STATEMENT OF RESPONSE TO AN BORD PLEANÁLA PRE-APPLICATION CONSULTATION OPINION

Proposed Strategic Housing Development

Lands at Oldtown, Swords, Co. Dublin

Applicant: Gerard Gannon Properties

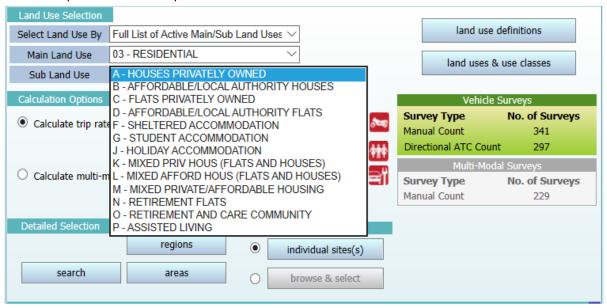
- Traffic and Transport Fingal County Transportation Planning Section noted in their SHD Stage
 departmental report comments with respect to trip generation calculations and the use of
 Census data. Per prior liaison with FCC Transportation planning, the following is noted:

- Trip generation has been calculated using TRICS Person trip rates for the Mixed Residential Development 'Flats and Houses' category and applying Census 2016 Modal Split to derive the multi-modal trips. One of the concerns raised by FCC noted that the calculated trips might be underestimated as "Flats" trip rates tend to be lower than "Apartments" trip rates. This concern was noted and a new consultation of TRICS Database was undertaken. In this consultation it was observed that TRICS Software does not include an option for "Apartments", and instead uses the term "Flats", which has been considered synonymous to "Apartments" See print screen below.

- Another raised concern in relation to trip generation calculation, is the Census 2016 Modal Split being applied to the calculated Person Trips to derive the all-mode trips (including car trips). This concern is noted, and the used methodology has been revised. The revised calculation has been based on TRICS Car trip rates as opposed to TRICS Person trip rates. With the car trips calculated, the bus, train, walk and cycle trips will then be estimated based on Census 2016 Surveyed Modal Split and on the 2027 Modal Split for Oldtown/Mooretown area contained in the South Fingal Transport Study Swords Sub Report (2019) prepared by SYSTRA on behalf of FCC. Note that, the Car trips have been calculated after TRICS Car trip rates and the remaining trips (train, bus, walk, cycle) have been estimated based on the best available Modal Split trends for the area.
